Integrated Device Technology, Inc.

## HARDWARE FIX FOR 77201 REV. C3 AND REV. D SAR ERRATA

TECHNICAL NOTE TN-29

This tech note is to describe the hardware used to fix the following items in the errata dated June 18, 1996:

**77201 REV. C3 and D External Hardware Fix**

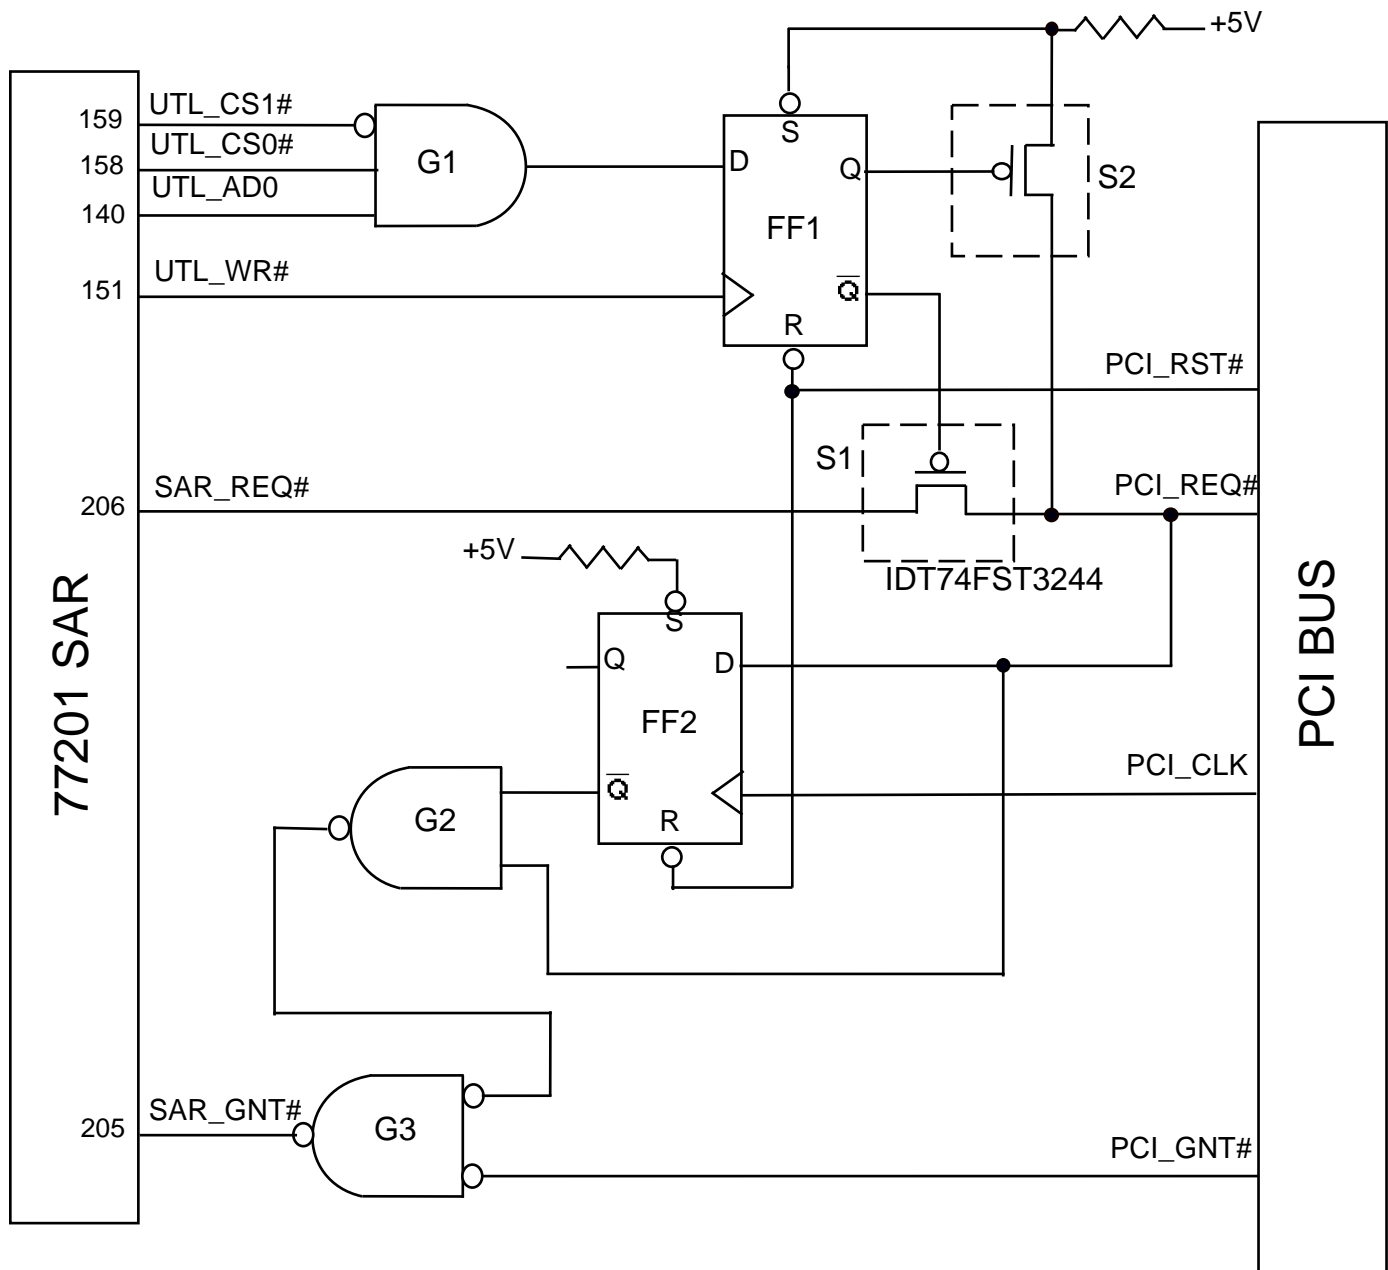
#### Errata #9: The timer rolls over before the 77201 is initialized.

This situation will cause the 77201 to generate a TSI (Transmit Status Indicator) in the TSQ (Transmit Status Queue). This is accomplished by DMAing the timer rollover indicator into host memory at the TSQ address. If the 77201 is not initialized with a proper TSQBA (Transmit Status Queue Base Address) register with a non-zero value, the 77201 will write the TSI to host memory location zero. This may cause some operating systems to crash.

#### Errata #14: Intolerance of controllers that are non-compliant to the PCI spec.

Some PCI chip sets arbiters do not take away PCI  $\overline{\text{GNT}}$  until one PCI clock after  $\overline{\text{REQ}}$  becomes de-asserted. This delayed de-activation of the  $\overline{\text{GNT}}$  will make the 77201 a park master according to the PCI Spec. To optimize the PCI bus utilization, the 77201 could start a PCI cycle when it is a park master (in the next PCI clock - the same time that the  $\overline{\text{GNT}}$  is being de-activated). Correct operation should allow the 77201 to complete the transfer. Some controllers have been observed to violate this function (e.g. the new low-end versions of the Power Macintosh and the IBM DX4-100 model 330).

The hardware fix requires a Quickswitch to isolate the 77201 PCI bus request line ( $\overline{\text{SAR\_REQ}}$  in the diagram) from the PCI bus at PCI power-up reset. This effectively disables DMAs by the SAR. When the device driver initializes the 77201 (including the TSQBA register), it should enable the  $\overline{\text{SAR\_REQ}}$  signal by writing to the utility bus with  $\text{UTL\_CS1} = 0$ ,  $\text{UTL\_CS0} = 1$ , and  $\text{UTL\_AD0} = 1$ . Also, when the 77201

device driver is un-loaded,  $\overline{\text{SAR\_REQ}}$  can be turned off by writing to the utility bus with  $\text{UTL\_CS1} = 0$ ,  $\text{UTL\_CS0} = 1$ , AND  $\text{UTL\_AD0} = 0$ .

Hardware used in the diagram to accomplish this function is: S1, S2, FF1 and G1.

To allow tolerance to these non-compliant controllers, hardware consisting of an OR-gate to block off  $\overline{\text{GNT}}$  to the 77201 one PCI clock after the  $\overline{\text{REQ}}$  becomes de-asserted (this additional clock is required by the non-compliant PCI chip set to take away  $\overline{\text{GNT}}$ ).

Hardware used in the diagram: FF2, G2 and G3.

Note: all components except the IDT74FST3244, can be put inside a single PLD. An alternate part to IDT74FST3244 is the IDT74FST6800, which combines the S1 and S2 internally to cut down the PCI bus loading.
